Attachment B: Detailed BDAR review against BAM requirements (BCD)

- The transmission connection is approximately 9 km through predominantly natural vegetation within Kosciuszko National Park and adjoining state forest.
- Disturbance area is approximately 143 ha within a construction envelope of approximately 224 ha (74% NPWS estate, 26% State forest)
- Overlaps with the approved Snowy 2.0 Exploratory / Main Works footprint by 6.9 ha.

Figure B.1 Elevation profile for Snowy 2.0 Transmission Connection, west to east (Google Earth Pro)

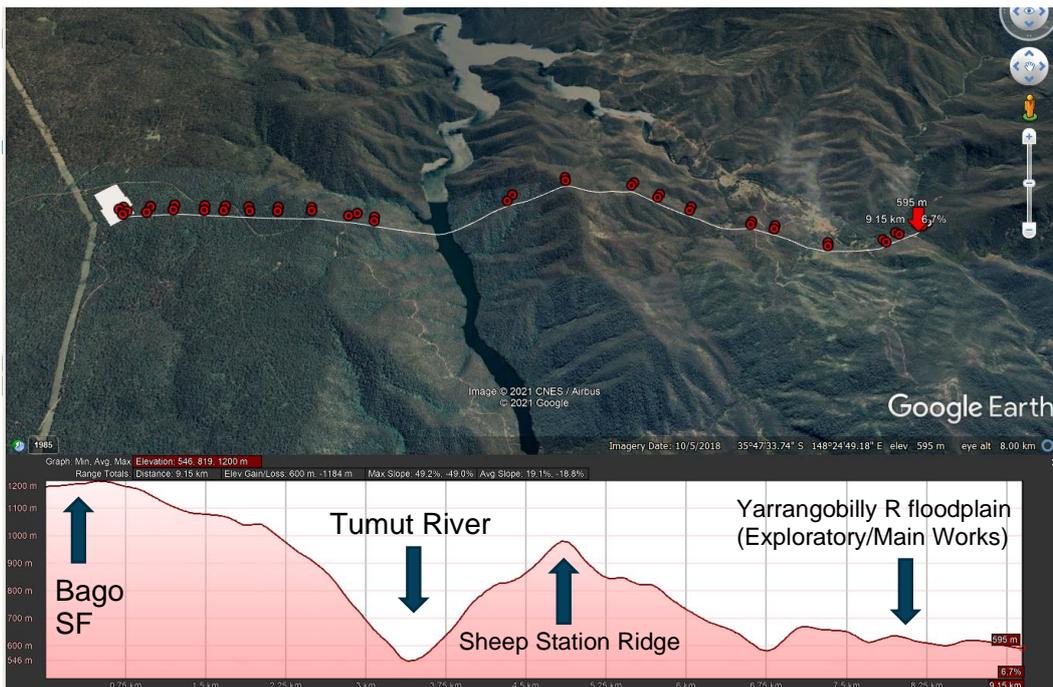
BCD consider that removal of vegetation and ground disturbance during construction is likely to alter surface hydrology and result in mobilised sediment along natural drainage lines. This is likely to result in spread of water-dispersed weed seeds along those drainage lines into the Yarrangobilly River floodplain.

The second paragraph under Section 8 Aquatic Assessment (page 175) describes the probable path of surface water within the vicinity of the project. It is clear from this description that drainage from the project site will flow into the Tumut River and Talbingo Reservoir, and to Yarrangobilly River via Sheep Station Creek, Lick Hole Gully, Cave Gully, and Wallace's creeks. The very steep slopes are shown in photos 8-17 and 8-18 (page 182), and an elevation profile in Figure B.1 shows the topographical changes along the proposed line.

Figure B.2 Fire Severity mapping

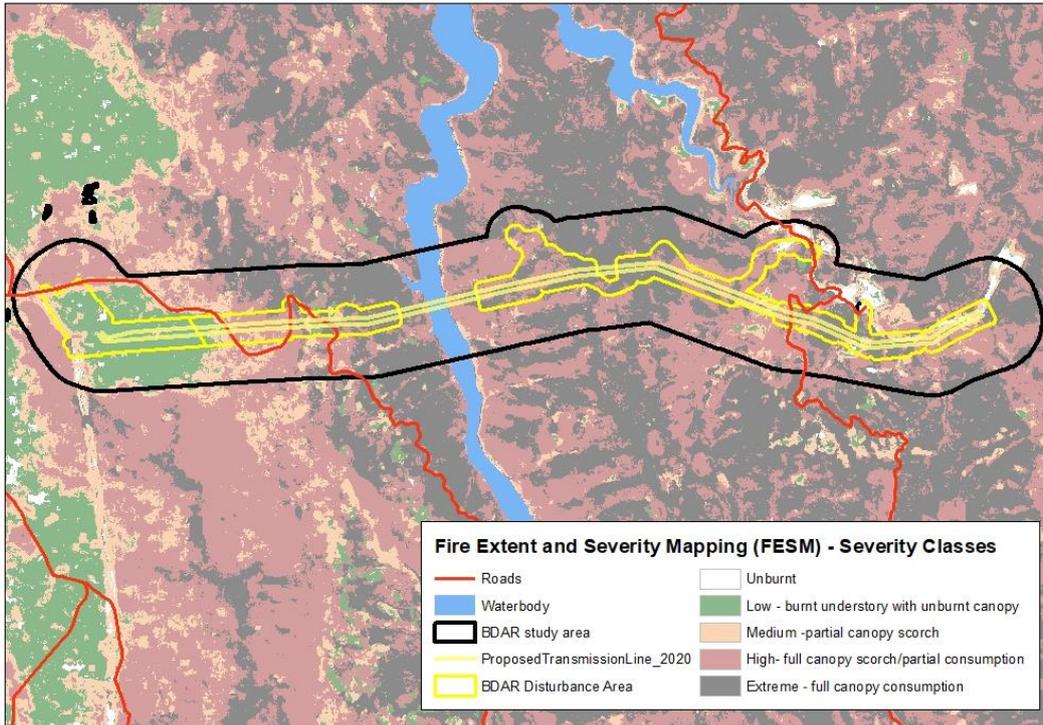
22. The more recent bushfire severity data (FESMv2.1) should be identified in the BDAR and used to guide management and mitigation actions specified in post-approval construction and operational plans.

The impact of the 2019/20 catastrophic fire season is discussed in Section 5.9 (page 83). The bushfire severity mapping shown on Figure 5-2 (page 86) is based on the 'Google Earth Engine Burnt Area Map' (GEEBAM) spatial dataset available on the NSW government SEED data portal, which maps relative burnt area canopy classes and is useful for preliminary, broad-scale assessments. BCD acknowledge that the 'Guideline for applying the BAM at severely burnt sites' specifies use of the GEEBAM data, however in mid-2020 this dataset was superseded for indicating fire severity by the 'Fire Extent and Severity Mapping' (FESM). FESM is based on field-validated data and more appropriate for use at a site scale (Figure B.2).

22.1. Ensure that the most recent version of ‘Fire Extent and Severity Mapping’ (FESM) is used for planning rehabilitation and biodiversity monitoring programs in post-approval construction and operational management plans.
